# PLANNING COMMISSION MEETING AGENDA REGULAR MEETING

SUBJECT: PRELIMINARY SITE PLAN REVIEW (File Number SP JPLN2015-0014) – Proposed Aloft Hotel, East side of Troy Center Drive, South of Big Beaver (PID 88-20-28-101-067), Section 28, Currently Zoned BB (Big Beaver) District

## Preliminary Site Plan Review For City of Troy, Michigan

<b>Applicant:</b>	Group 10 Management
<b>Project Name:</b>	Aloft Hotel
<b>Revised Plan Date:</b>	July 6, 2016
<b>Location:</b>	Southeast corner of Big Beaver Road and Troy Center Drive (southeast corner of site)
<b>Zoning:</b>	BB, Big Beaver Form-based district
<b>Action Requested:</b>	Preliminary Site Plan Approval
<b>Required Information:</b>	Deficiencies noted

1-PROPOSED WEST ELEVATION

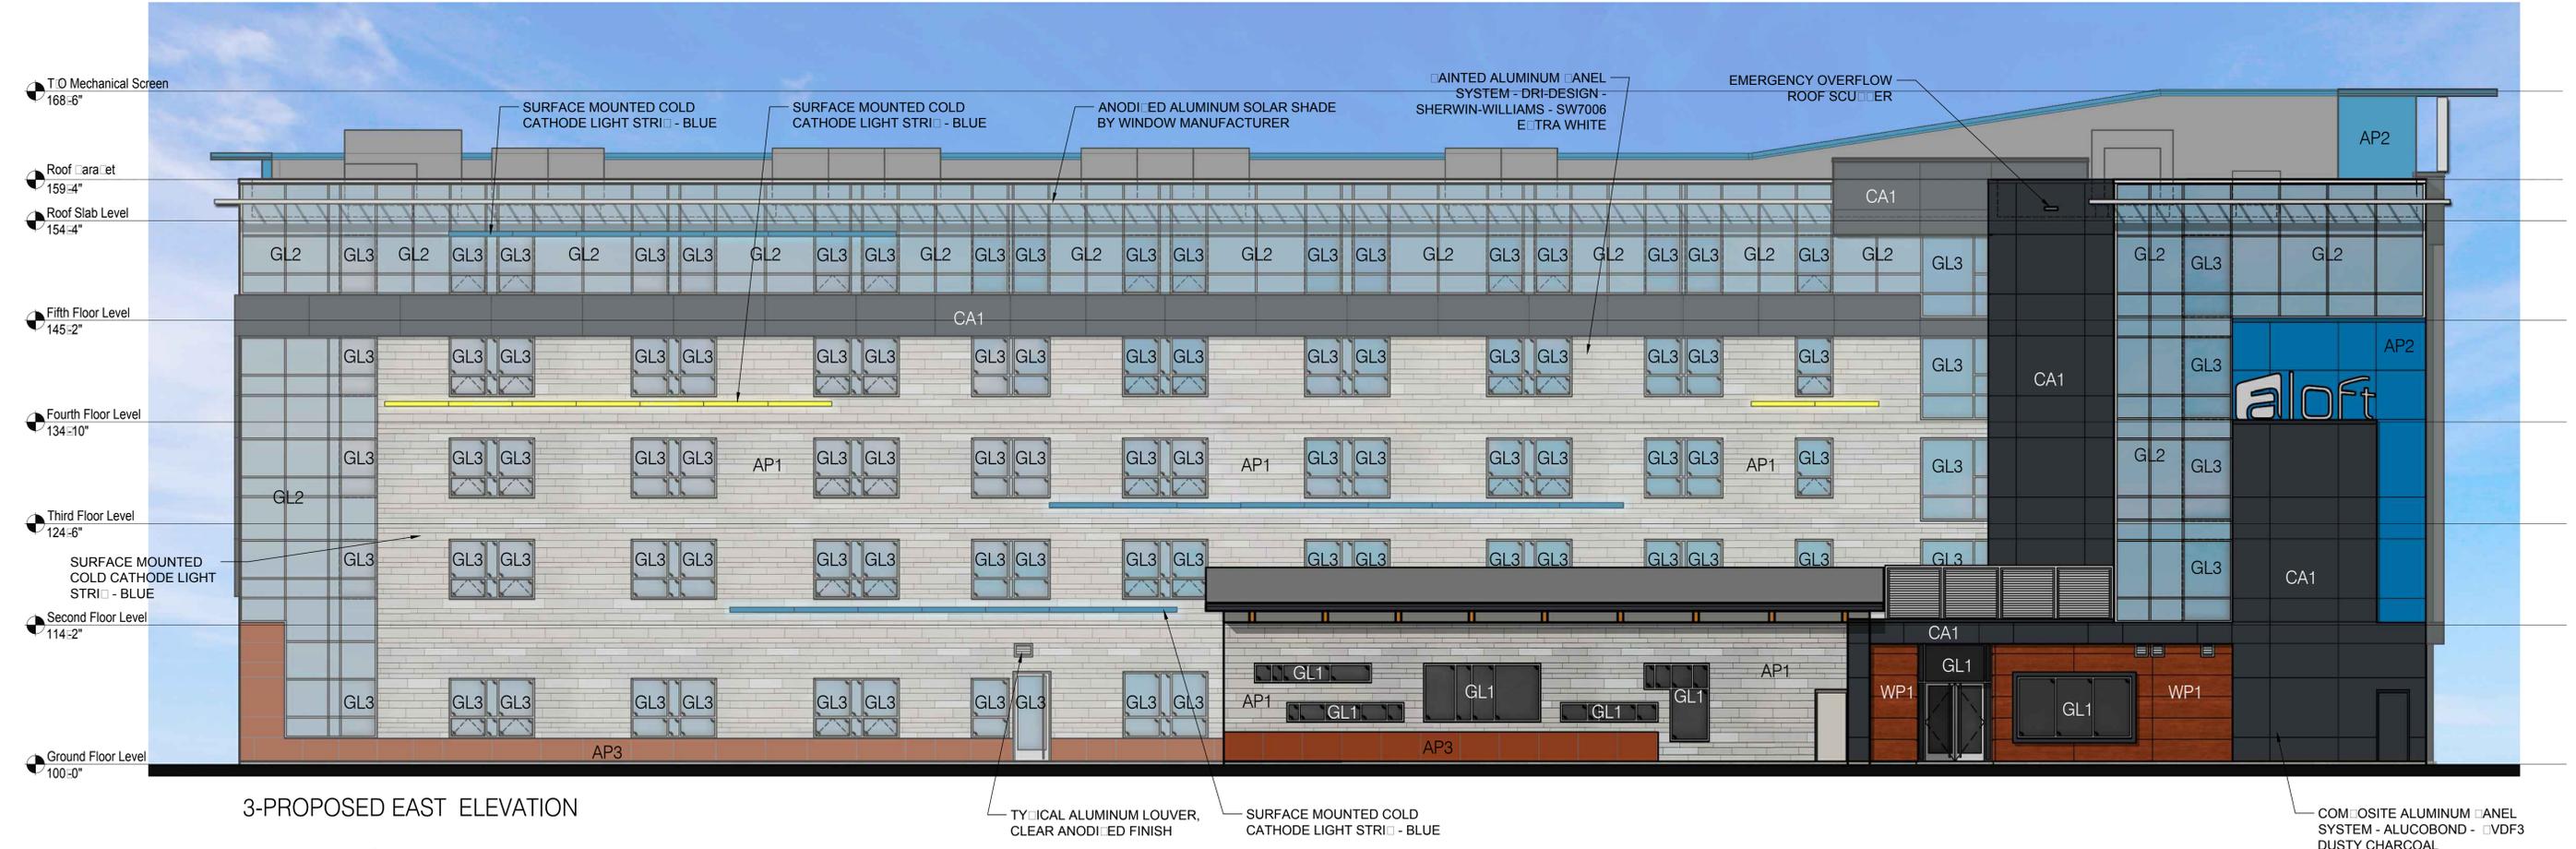
1. Provide the shared parking agreement and location of shared parking as part of the final site plan.
2. The applicant shall use clear glass for the area noted as “1<sup>st</sup> floor public space glazing” that is located at the canopy entrance.
3. Submit a lighting plan in compliance with Article 13 that includes fixture details and photometrics.
